METROPOLITAN GOVERNMENT OF NASHVILLE AND DAVIDSON COUNTY

STAFF RECOMMENDATION
1309 Beechwood Avenue
June 17, 2014

Application: New construction—addition and Detached accessory dwelling unit;
Setback determination

PROPOSED LEFT ELEVATION

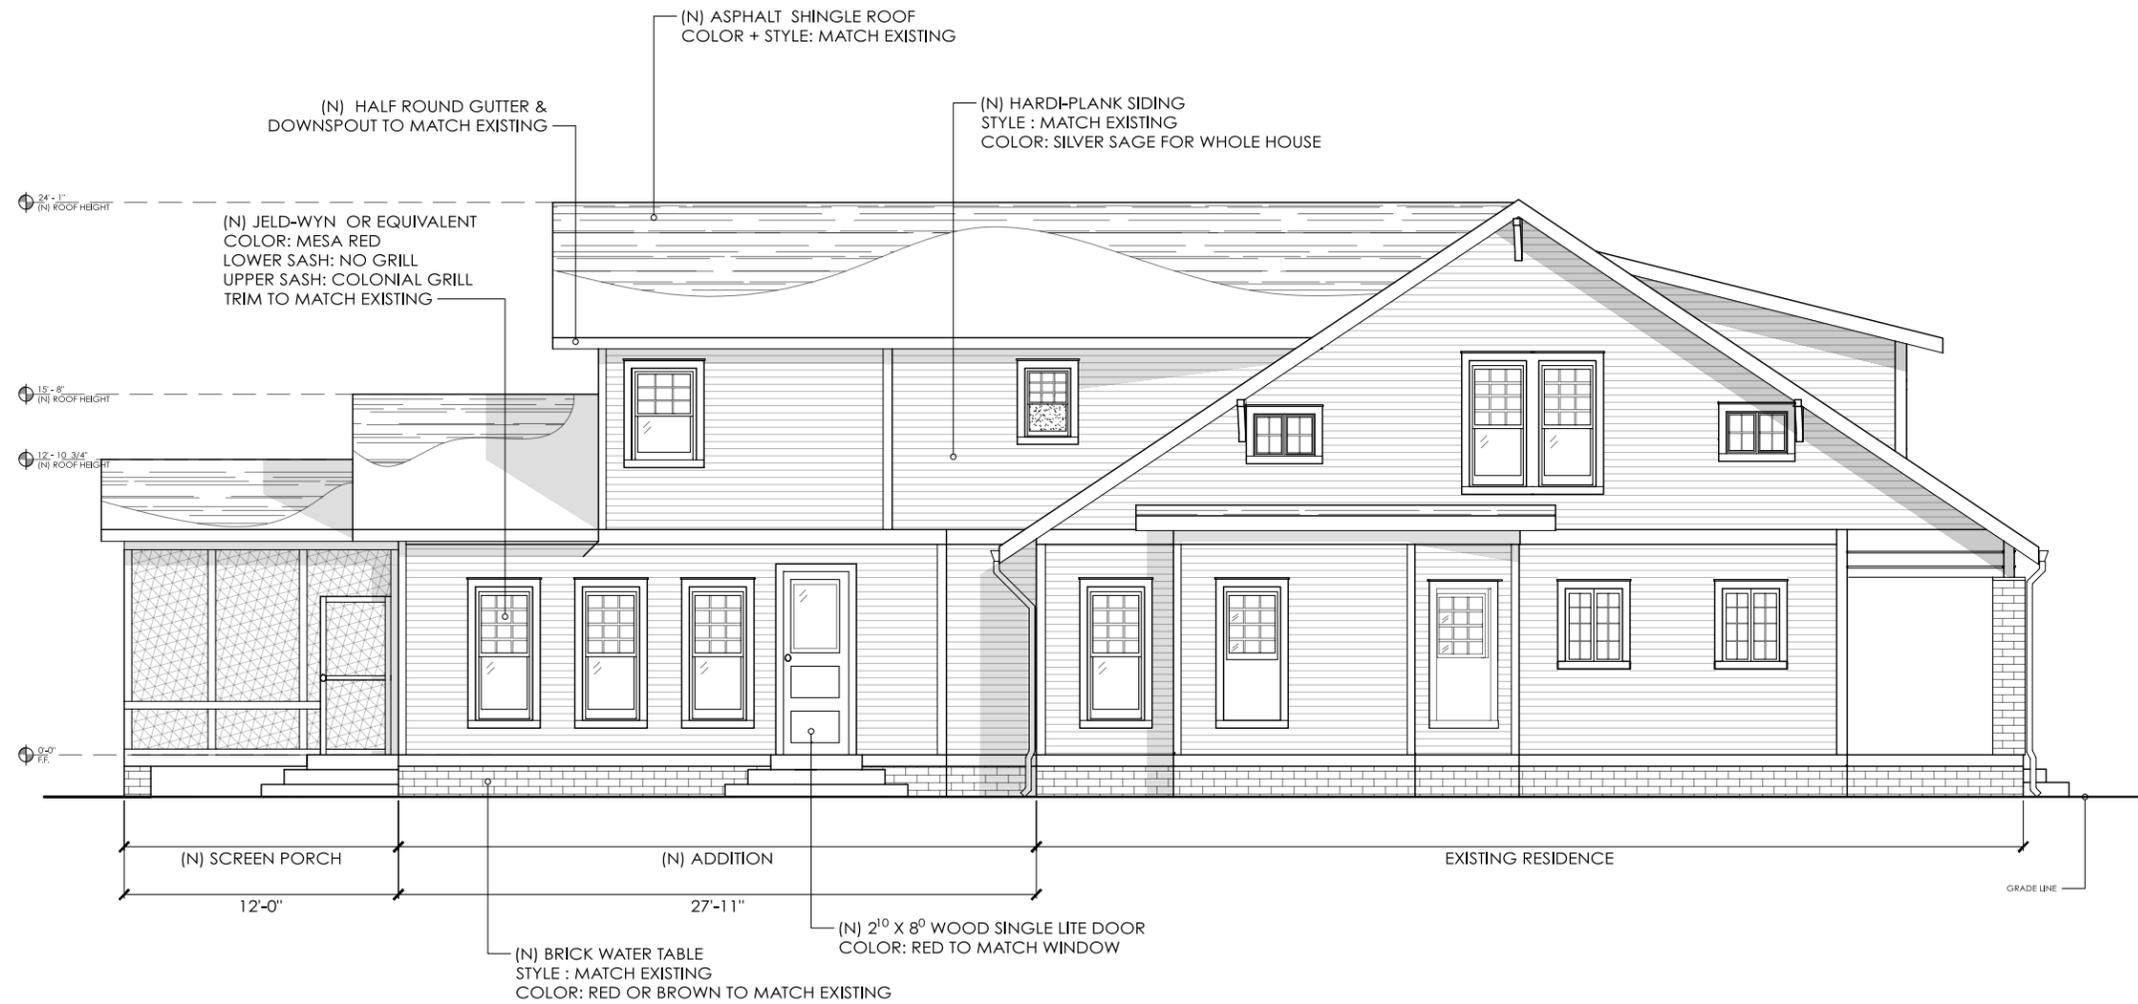
Orientation: The addition will not alter the historic house's orientation towards Beechwood Avenue. The addition does include a side entry on the left façade. This entry is subordinate to the primary entry on the front façade. It does not have a covered porch, and is a simple doorway entry. Vehicular access to the site will be via the rear alley and an existing driveway at the front. Staff finds that the addition meets Sections II.B.1.f. and II.B.2. of the design guidelines.
